Access Compliance Report

Public Rights-of-Way

(Curb Ramps)

Intersection ID: 47903	Main Street: SPUR_RANCH_RD	Cross Street: ROUND_ROCK_RD	Location: SW
ADA ID: 19BE47008B35	Ramp Type: PerpDiag	Initial Pass/Fail: Fail	Overall Compliance: No
		Severity Score: 25

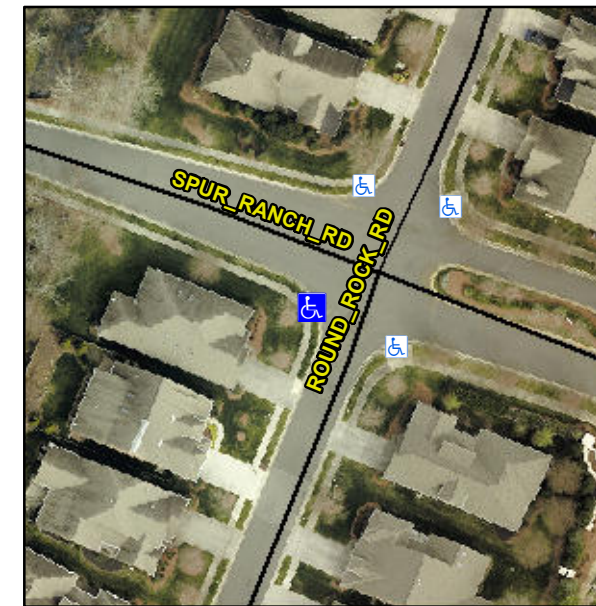
Not Found, R304.2.2

Compliance	Description	Data	Compliance	Description	Data
N/A	Ramp Length (in)	48.0	No	Ramp Slope (%)	12.1
Yes	Ramp Width (in)	48.0	Yes	Ramp XSlope (%)	0.8
N/A	Flare Type LT	N/A	N/A	Flare Type RT	N/A
N/A	Flare Slope LT (%)	N/A	N/A	Flare Slope RT (%)	N/A
N/A	Flare Traversable LT?	N/A	N/A	Flare Traversable RT?	N/A
N/A	Landing Length (in)	N/A	N/A	DWS Provided?	N/A
N/A	Landing Width (in)	N/A	N/A	DWS Contrast?	N/A
N/A	Landing Slope (%)	N/A	N/A	DWS Length (in)	N/A
N/A	Landing X Slope (%)	N/A	N/A	DWS Full Width?	N/A
N/A	Landing Curb? (Y/N)	N/A	N/A	DWS Offset (in)	N/A
N/A	Shared Landing?	N/A			
N/A	Gutter Ponding?	N/A	N/A	Gutter Slope (%)	N/A
N/A	Gutter Lip Ht (in)	N/A	N/A	Gutter X Slope (%)	N/A
N/A	Painted X Walk1?	No	N/A	Painted X Walk2?	No
	X Walk 1 Direction	To SE		X Walk 2 Direction	To NE
N/A	X Walk 1 Width (in)	N/A	N/A	X Walk 2 Width (in)	N/A
	X Walk 1 Slope (%)	2.5		X Walk 2 Slope (%)	0.3
	X Walk 1 X Slope (%)	2.2		X Walk 2 X Slope (%)	1.5

Remove & Replace Curb Ramp With Two New Directional Ramps or Equivalent.
